CABINET MEMBER FOR ENVIRONMENT – 12 SEPTEMBER 2019

OXFORD, RYMERS LANE JUNCTION WITH LITTLEHAY ROAD & CORNWALLIS ROAD – PROPOSED TRAFFIC CALMING

Report by Director of Community Operations, Communities

Project:
**Rymers Lane/
 Littlehay Road
 Speed Table
 2019**

Title:
General Layout Plan

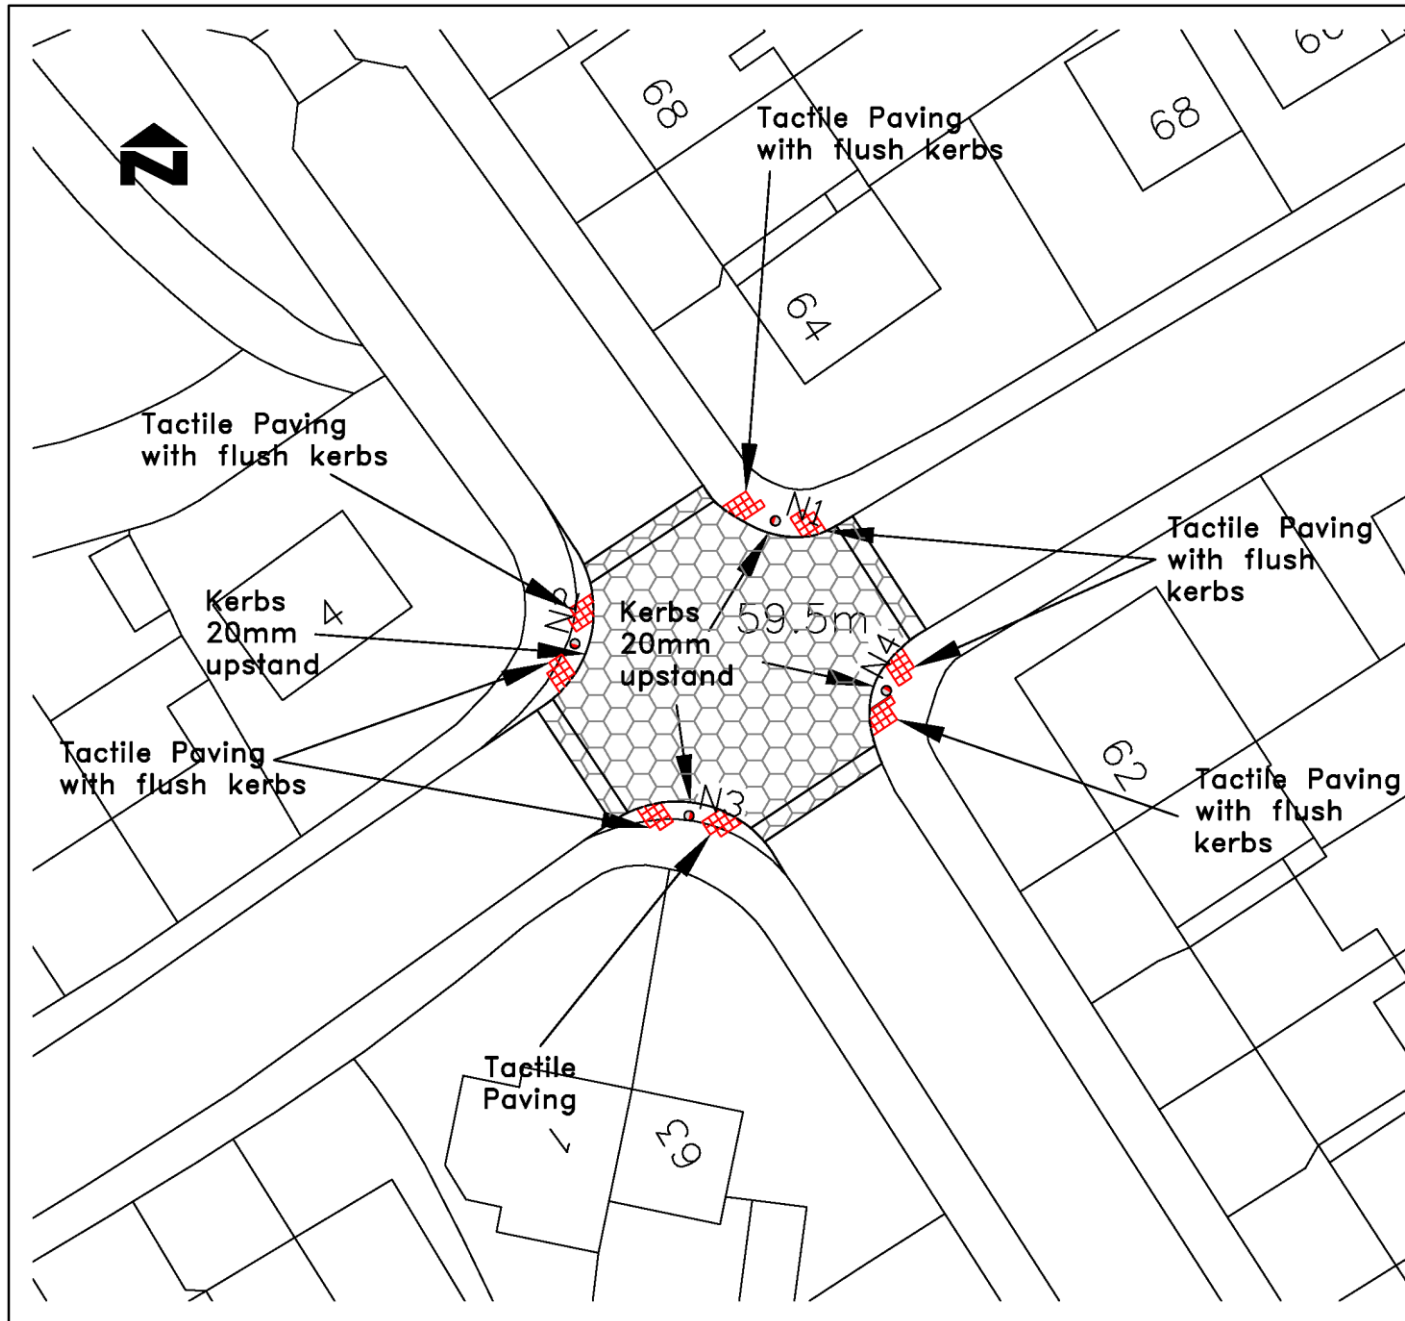
RESPONDENT	SUMMARISED COMMENTS
(1) Traffic Management Officer, (Thames Valley Police)	No objection
(2) Local Resident, (Oxford)	<p>Object - I have lived very near to the junction in question for over 12 years, only once during this time have I ever seen an accident/the clean-up, it was not a big accident.</p> <p>The awareness of road users has improved in this area over time and I think these proposed changes constitute a waste of time, effort and money.</p>

(3) Local Resident, (Oxford)	<p>Object - My children cross over Cornwallis Rd at this junction every day on the way to school. This table doesn't solve the problem at this junction as I see it.</p> <p>At busy times (e.g. during the school run) traffic queues up to the junction from all directions making it very difficult to cross the road with children (we have to wait for someone to let us cross, and then weave through queuing traffic with a pushchair + 3 kids under 10). It is also unsafe for cyclists due to the volume of queuing and parked cars.</p> <p>At less busy times cars approach the junction far too fast. Again making it difficult to cross on foot and unsafe for cyclists.</p> <p>I don't see how this table will reduce the amount of traffic (and pollution), make it safer to cross, or safer to cycle.</p> <p>I'd like to see a scheme for this area which actually reduces the number of cars and prioritises walking and cycling at this junction and across the local area.</p> <p>However, if this table does go ahead then an improvement for pedestrians would be to add give way lines for cars before the ramp on each side (e.g. like at the junction of Henley Street and Iffley Road). Better still a zebra crossing over Cornwallis Rd and Littlehay Road would be an improvement.</p>

<p>(4) Local Resident, (Oxford)</p>	<p>Object - I object on the following grounds:</p> <p>Cost and lack of joined-up-planning. A costed proposal for a low-traffic residential zone for this area has recently been funded by local residents and businesses under the umbrella of the Oxfordshire Living Streets organisation. Any spend of thousands of pounds of taxpayer money should await the publication of this proposal to see if the money can be better invested in conjunction with recommendations of this proposal.</p> <p>Kerb Radius: As a regular user of this junction with my children as pedestrians, it needs further improvements to meet our needs. The desire-lines of continuing from the pavements across the junction (without turning) have pedestrians passing on the inside (closest to the junction) of the proposed bollards. The kerb radius should be reduced to 4.5m. This would keep these desire-lines open and further slow the speed of motor vehicles, whilst remaining accessible for emergency/refuse vehicles/etc. Any modelling of the junction should assume larger vehicles will need to cross both lanes of the Littlehay Road arms when turning, rather than compromising the pedestrian experience.</p> <p>Drainage: No mention of the drainage requirements is in the published documents. Water currently flows from the south of Rymers Lane, around the corner to a drain on the east arm of Littlehay Road. Appropriate drainage works are essential if this is to be a raised table without creating standing water after rain.</p> <p>Approach: I also regularly use this junction with my children as cyclists. A straight 1:12 gradient is not suitable for cyclists, and this should instead be a "sinusoidal" profile, shallow at the bottom and top, and steeper in the middle of the sloping area, with an average gradient of 1:15. The approach from both directions of Littlehay Road need to be longer, to account for groups of cyclists (there are 5 in my family) to be able to give-way without any cyclists being on the slope.</p>

<p>(5) Local Resident, (Oxford)</p>	<p>Object - The proposed 'traffic calming' will do little or nothing to address the wider road use issues in this part of Oxford, namely 'rat-run' traffic avoiding Cowley Centre, and overuse of cars on the school run to St Gregory's. This type of 'raised table' seems similar in concept to those in use on Magdalen Rd and Howard Street and are completely unsuitable for use on a signed cycle route.</p> <p>Vehicle speed is more effectively managed by lane narrowing, and traffic volume is better managed through modal</p>

<p>filters. I would commend to you the suggestions by Oxfordshire Liveable Streets in their 'mini-Holland' LTN plan.</p>
<p>(6) Local Resident, (Oxford)</p>	<p>Neither/Concerns - I am concerned about the proposed traffic calming feature, because it won't slow the rat run on the whole of Cornwallis road. Cars will speed up again as soon as they have crossed the junction, and probably just as they are going past my house.</p> <p>I would prefer traffic calming measures that would be effective on the whole road, such as average speed cameras. It has also become even faster because the 20 mile an hour signs have disappeared.</p>
<p>(7) Local Resident, (Oxford)</p>	<p>Neither/Concerns - I think this is a waste of money and will not solve the problems of this extremely dangerous junction. I would very much like improvements to the junction though!</p> <p>In my opinion, the danger is not primarily due to speed, but due to the excessive volume of traffic using the junction for rat running, particularly in the morning and at school pick up. This coincides with the time that large numbers of pedestrian schoolchildren are navigating the junction.</p> <p>As a pedestrian crossing Littlehay road, you often need to try and make eye contact with drivers queuing on both sides of the junction to judge if it is safe to cross.</p> <p>I strongly support improvements to the junction, but I don't think this is the right solution to improve it for pedestrians and cyclists. I hate navigating the raised junctions in Howard Street by bike or with a buggy; they make it more dangerous for me on a bike, and no safer as a pedestrian. I would rather the money was saved up for longer so that we could have a better solution. Other ideas:</p> <ol style="list-style-type: none"> 1. Double yellows running on all sides to improve visibility (currently often greatly impeded by parked cars particularly in Littlehay Road). Trim back the enormous hedge on the corner of Littlehay Road; traffic can only see me and the buggy when we are at the very edge of the pavement. 2. Clear priority for pedestrians and cyclists, probably in the form of Copenhagen crossings over both Littlehay and Cornwallis, where the footway and cycle lanes continue over the junction on a raised strip, making it clear to car drivers that they must let pedestrians cross.

<p>(9) Local Resident, (Oxford)</p>	<p>Support - As someone who has been knocked off their bicycle cycling along Rymers Lane by a car failing to stop when it approached this junction from Cornwallis Road, I cannot understand why you don't make it obligatory for cars to stop, rather than give way. Making it a stop junction would make it less likely for accidents at this junction.</p>
<p>(10) Local Resident, (Oxford)</p>	<p>Support - I broadly support the proposal, as it's clear some traffic calming is needed, but would want the council to monitor the new junction layout and report back on what difference it's making -- and whether problems crop up elsewhere as a result. Working with St Greg's to incentivise car-free transport would also be beneficial as the school run is a major cause of traffic.</p>

<p>(11) Local Resident, (Oxford)</p>	<p>Support - I'm a cyclist and feel vulnerable here because cars go fast, this is also an area near a park where children play.</p>
<p>(12) Local Resident, (Oxford)</p>	<p>Support - It would benefit from dedicated cycle lanes/'grooves' through the up stand given the volume of cycle traffic. Trees on the corners may help with aesthetics</p>
<p>(13) Local Resident, (Oxford)</p>	<p>Support - There should be more of these in this area. There should be more of an effort to reduce traffic in this area rather than just 'calming' it.</p>
<p>(14) Local Resident, (Oxford)</p>	<p>Support - Traffic in the Florence park area and Oxford road is unsafe. Any incentive to limit car speed would be beneficial to the area.</p>
<p>(15) Local Resident, (Oxford)</p>	<p>Support - Rymers Lane and Cornwallis Road are both currently dangerous roads, which are unattractive to both cyclist and pedestrians. I welcome the proposed traffic calming feature but consider that it does not go far enough. I would support further traffic calming measures especially 'filtering' by blocking off some roads to vehicular traffic in the Florence Park area and Oxford as a whole. Consideration should be given to a one-way system in this area to make 'rat running' unattractive.</p> <p>The proposed junction could be further improved by making it clear that pedestrians have priority crossing the road. This should include compulsory stopping for vehicles. Furthermore, it is important that the increase in the junction surface is significant enough to actually slow vehicles down and make it impossible for them to speed over it.</p>

<p>(16) Local Resident, (Oxford)</p>	<p>Support - Anything which improves safety at this dangerous junction is to be welcomed. It is unfortunate that, whilst this junction treatment does give some relief to pedestrians it does almost nothing to improve safety for cyclists. Some of the detail of the scheme is puzzling.</p> <p>A triangular give way road marking is shown on the road as vehicles approach from Cornwallis Road but not the opposite approach from Littlehay Road. Surely that road too should have a give way marking to slow vehicles down as they approach the junction?</p> <p>Narrowing the approach from Cornwallis is a good safety feature but is lacking in the Rymers Lane approach from</p>

the South East even though this is a downhill slope where vehicles will have recently exited onto a fast main road. Could that approach be narrowed too?

Instead of simply narrowing the road approach from Cornwallis Road could the council please consider a build out which constricts traffic whilst giving cyclists a safety lane? Please advise if that can be accommodated with the given road width?

9. The above concerns are noted. It is accepted that this proposal will not in itself address the wider traffic pressures in the area but will, nevertheless, improve safety at a location with a significant accident history comprising 2 serious and 9 slight injury accidents in the past 5-year period, 7 of those involving pedal cyclists. It will also contribute to making this area a less attractive route for 'rat-running' traffic.

10. The design of the junction table in respect of drainage, ramp gradient and kerb radii is consistent with other features of this type which have been found to operate with good levels of safety and to not present any hazard to pedal cyclists.

12. The desire for wider measures is again noted but further funding would be required to develop, consult and implement such a scheme and that is currently not available. It should also be noted again in respect of the other comments that the design is consistent with other junction tables.
